# Gunnison County Environmental Health Board

**GUNNISON COUNTY, COLORADO  
COMMUNITY DEVELOPMENT DEPARTMENT, ENVIRONMENTAL  
HEALTH OFFICE STAFF REPORT**

**John Mortell**

Application No: OWTS-24-00184  
Date application scheduled with EH Board: November 18, 2024  
Prepared by: Crystal Lambert, Building & EH Official

**1** SITE PLAN  
1/32" = 1'-0"

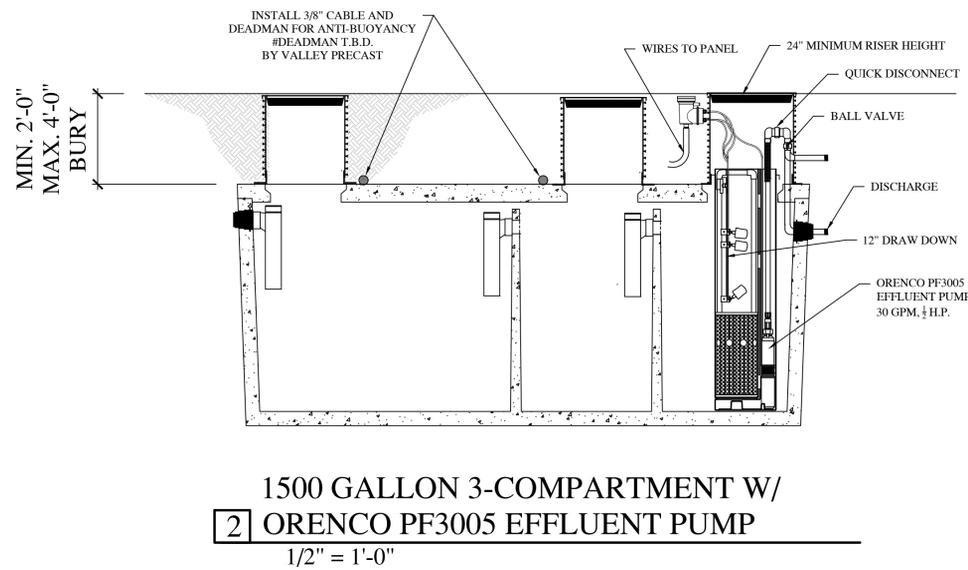
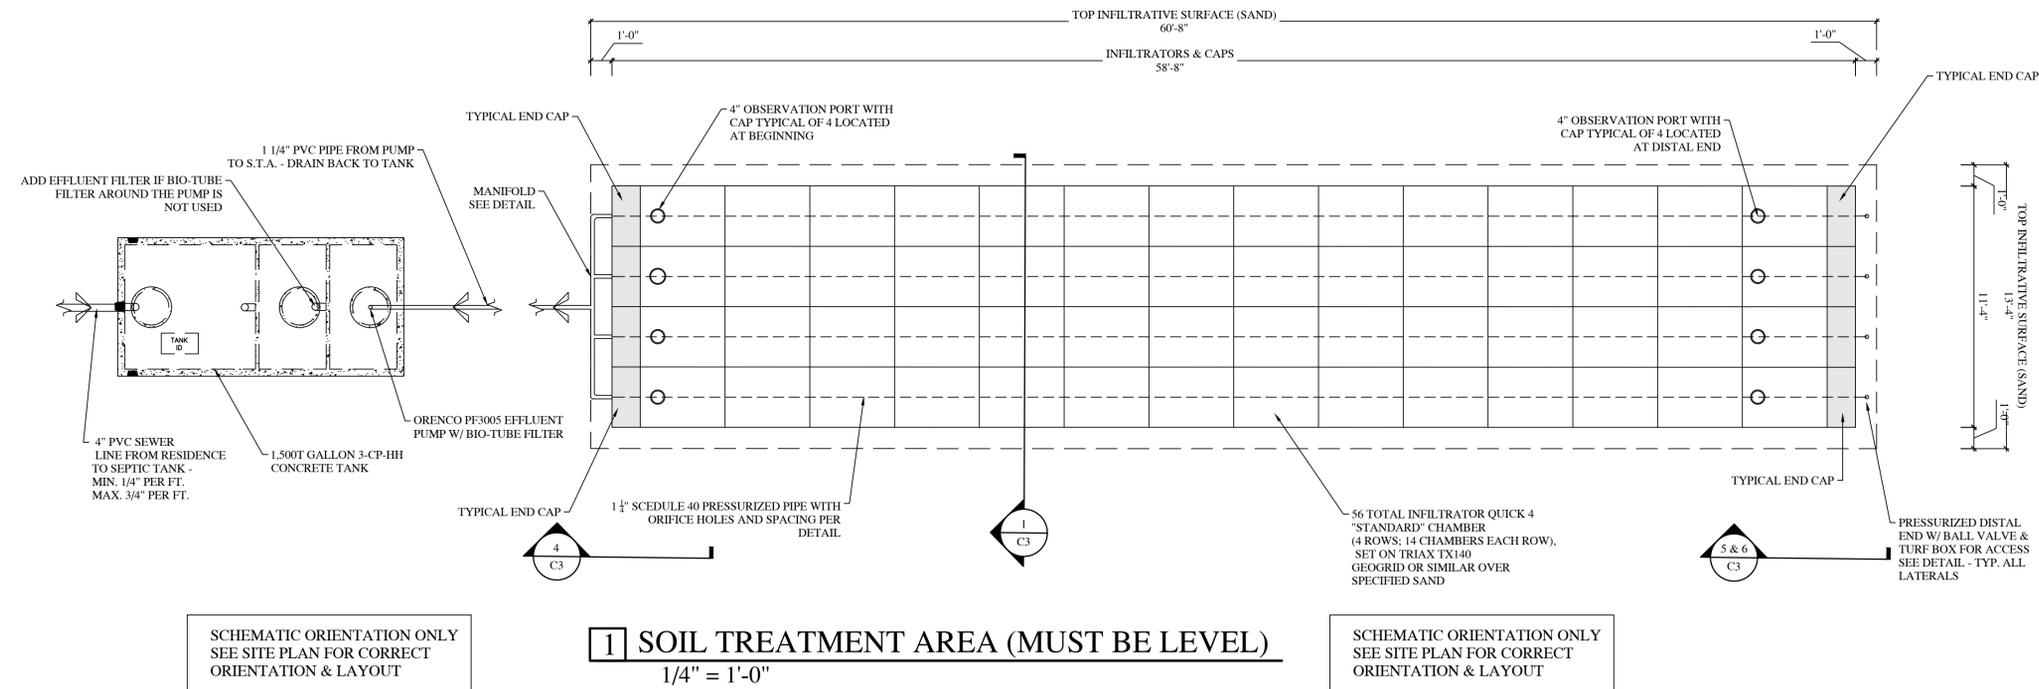
The application and proposed design plans have been reviewed by the Environmental Health Office for compliance with the Gunnison County OWTS Regulations. The proposed distance between the septic tank and the nearest wetland boundary is approximately 60 feet. The Gunnison County OWTS Regulations require 100 feet between septic tanks and water bodies, including wetlands.

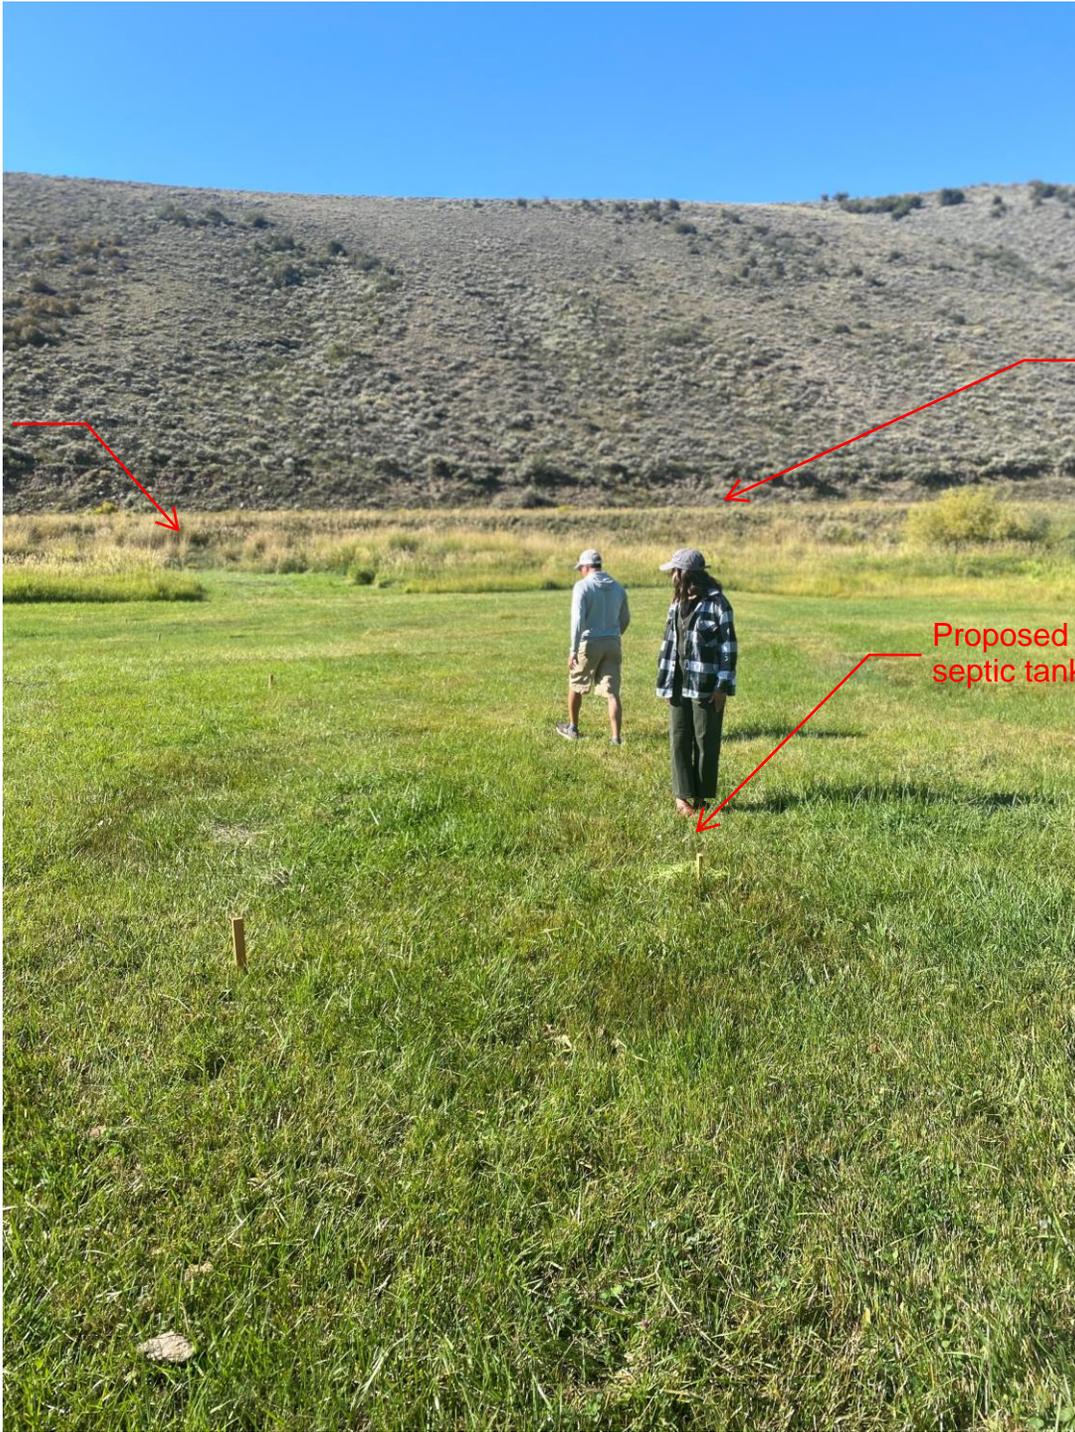
Variance needed for proposed location of septic tank in proximity to wetland boundary ~60feet. Verify proposed well location once installed. 100yr fp will require elevated control for pump and backflow prevention.

**Standing near road and facing North looking out at the property**

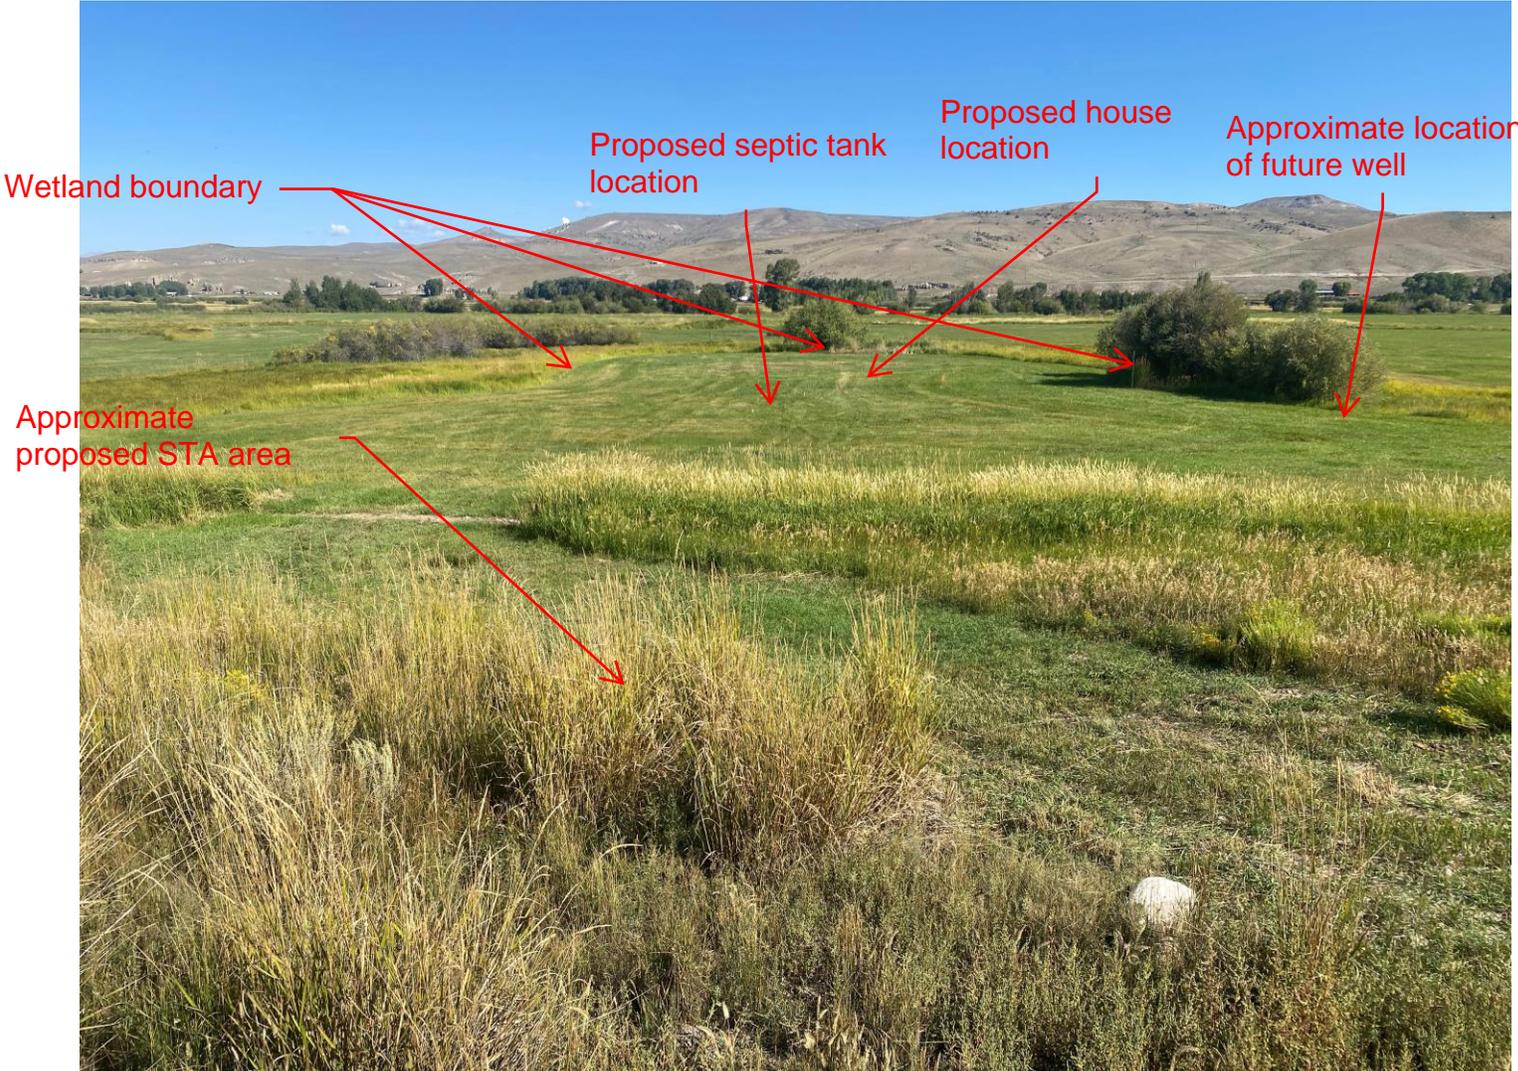
Irrigation ditch that will be lined within 100 feet of STA
